HISTORIC AND DESIGN REVIEW COMMISSION

April 19, 2017

HDRC CASE NO: 2017-163
ADDRESS: 131 W AGARITA AVE
LEGAL DESCRIPTION: NCB 1767 BLK 1 LOT 10, W15 FT OF 11
ZONING: R-4 H
CITY COUNCIL DIST.: 1
DISTRICT: Monte Vista Historic District
APPLICANT: Janet Molak
OWNER: Janet and Mike Molak
TYPE OF WORK: Fencing alterations, construction of open-air pool pavilion
REQUEST:

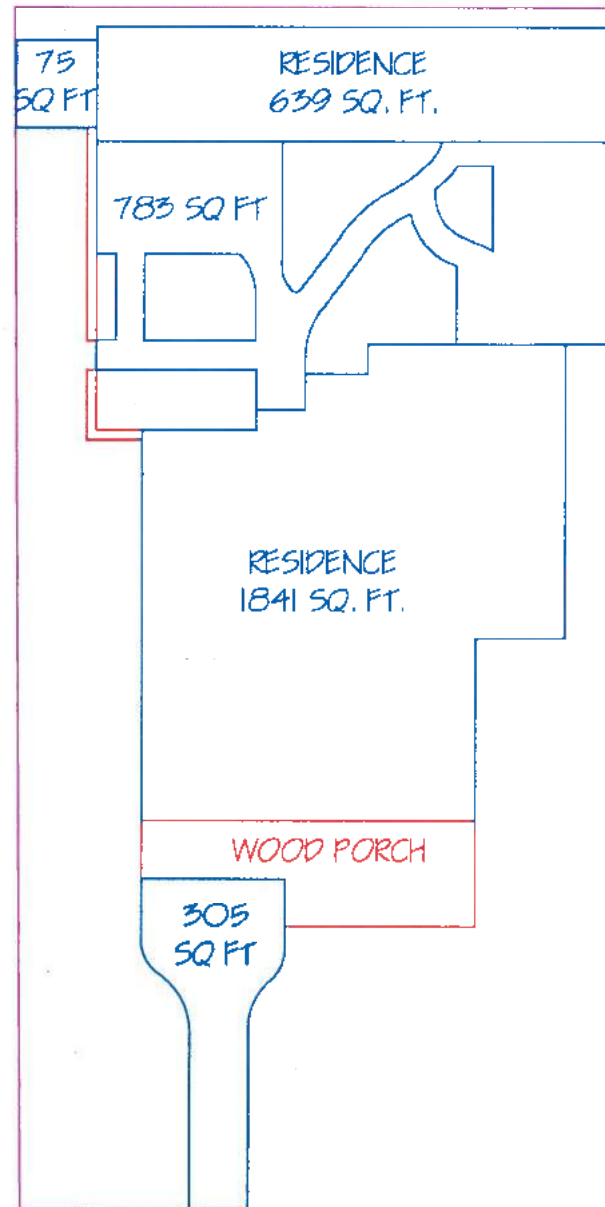
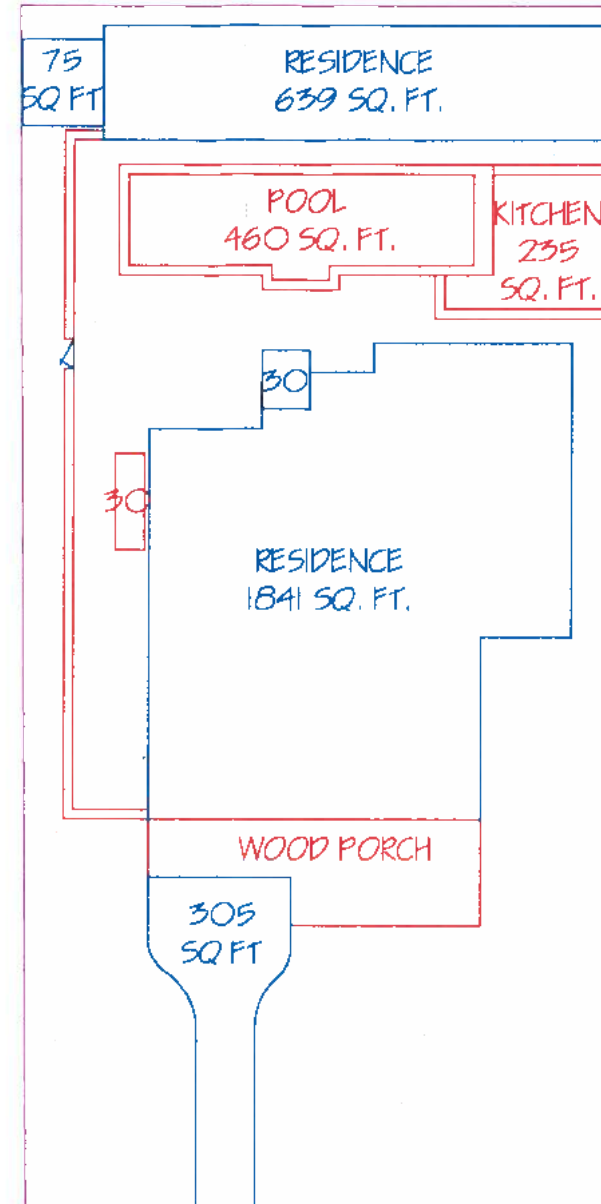
- b. FENCE REMOVAL - The existing fence is approximately 4 feet high and is constructed of stone. Stone fences are not characteristic of the architectural style and time period of the primary structure. Staff finds its removal acceptable.

- c. NEW FENCE INSTALLATION - The applicant has proposed to install a fence constructed of brick masonry units to match the existing structure. The fence boundary will be extended towards the front façade relative to the existing stone fence but will be offset from the front facade by 3 feet. The material choice is also compatible with the primary structure and brick fences and walls are common in the district. The fence materiality, size, and location is consistent with the Historic Design Guidelines for Site Elements and staff finds this proposal acceptable.

Move
fence back
3'

Remove
All to BASIC

1. Staff recommends approval of the fence removal based on findings a and b.
2. Staff recommends approval of the new fence installation based on findings a and c with the following stipulations:
 - i. Pool equipment storage is not visible from the public right-of-way.
 - ii. The fence complies with Historic Design Guidelines standards and is no taller than four feet. The final construction height of an approved fence may not exceed the maximum height as approved by the HDRC at any portion of the fence. Additionally, all fences must be permitted and meet the development standards outlined in UDC Section 35-514.
3. Staff recommends approval of the construction of a rear accessory structure based on findings a, d, and e.
4. Staff recommends approval of the pool installation based on finding f.

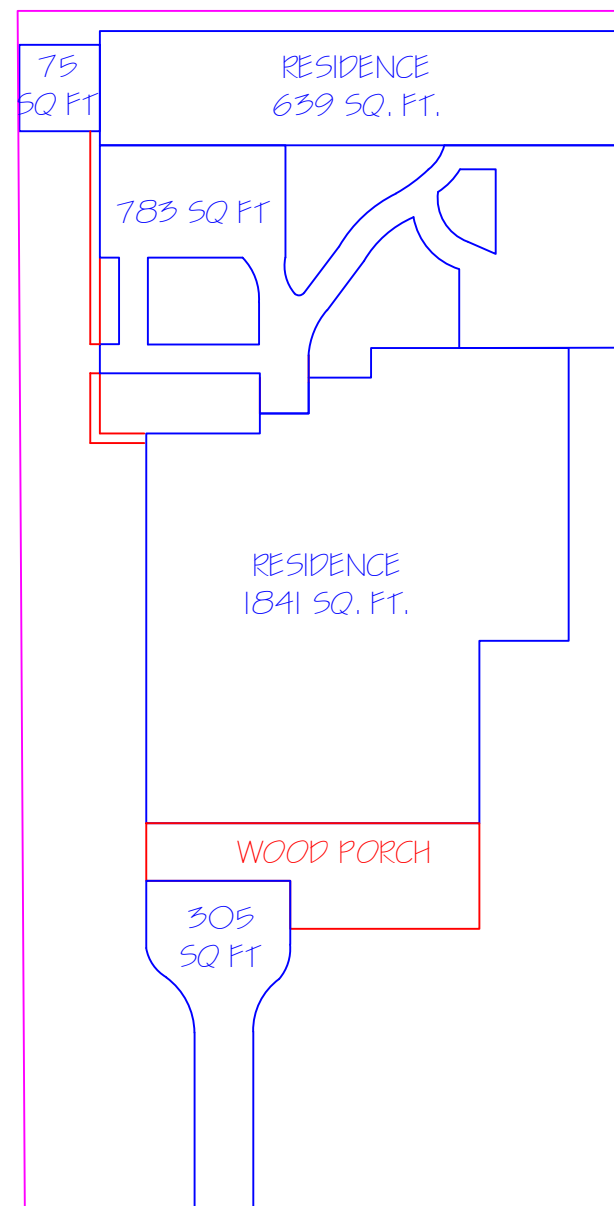
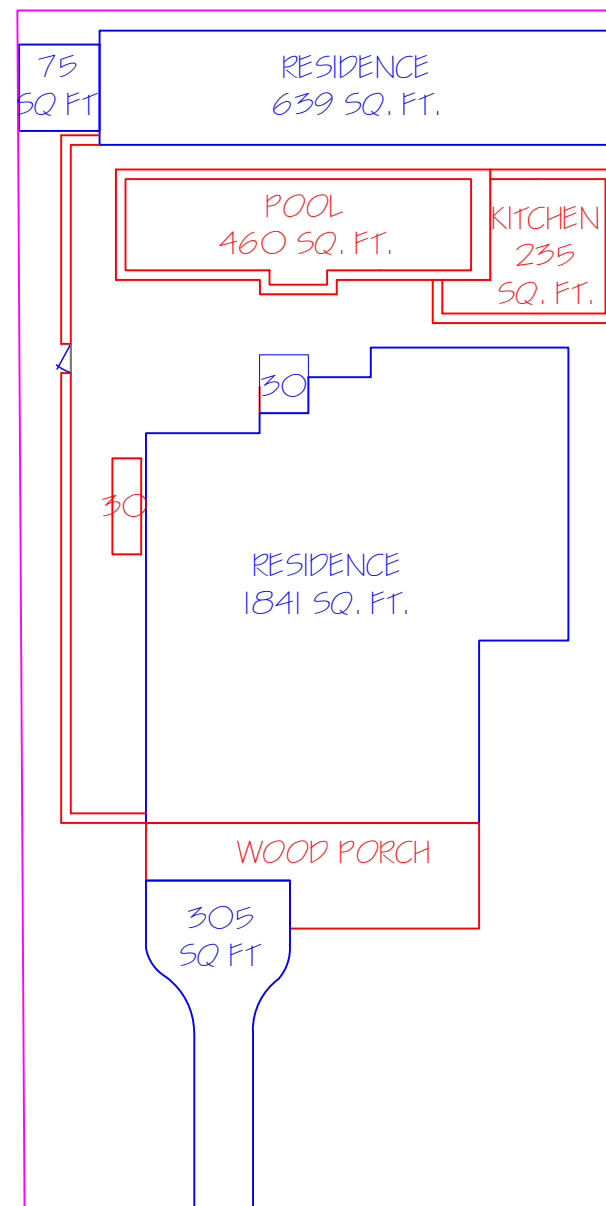
MOVE
fence back
3'

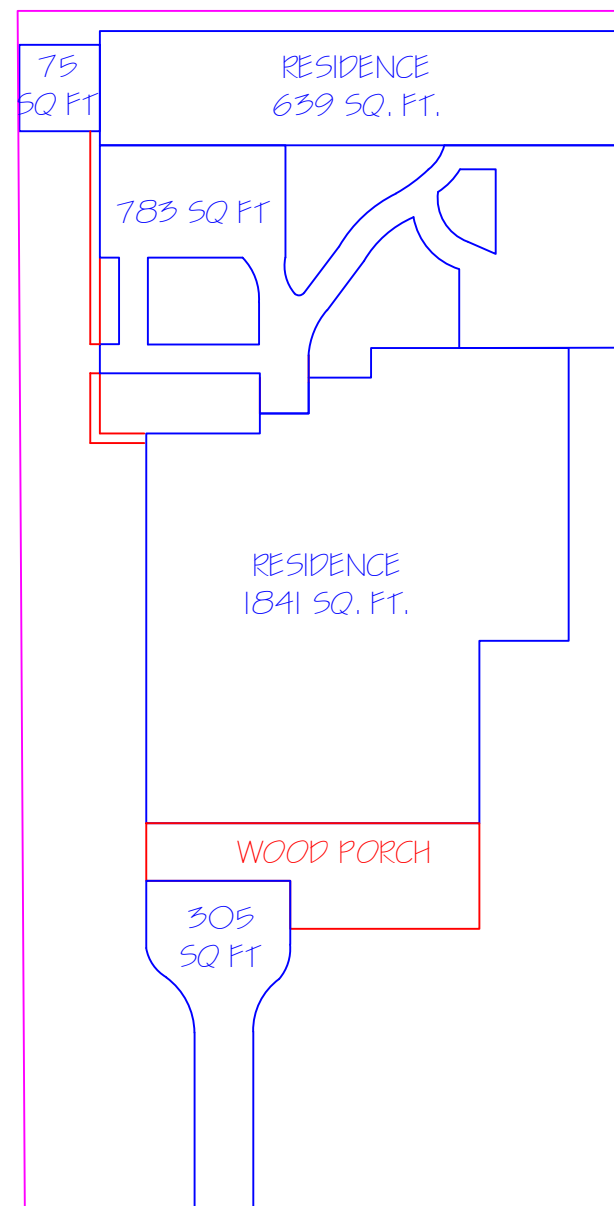
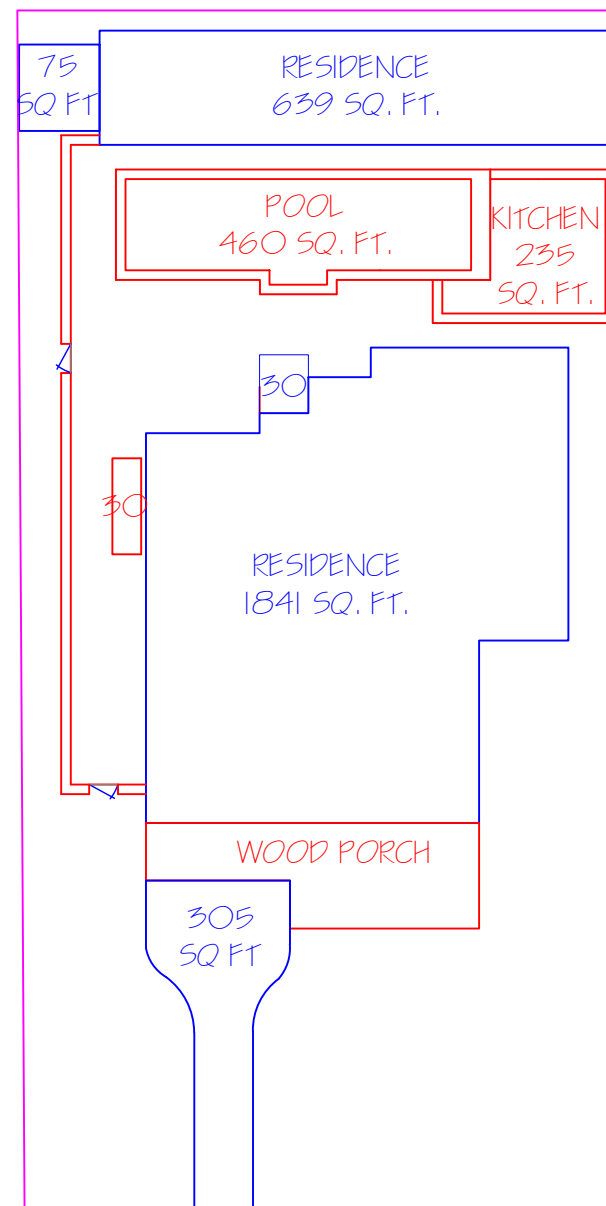
Move
fence back \leftarrow
3'

Remove
All in BACK
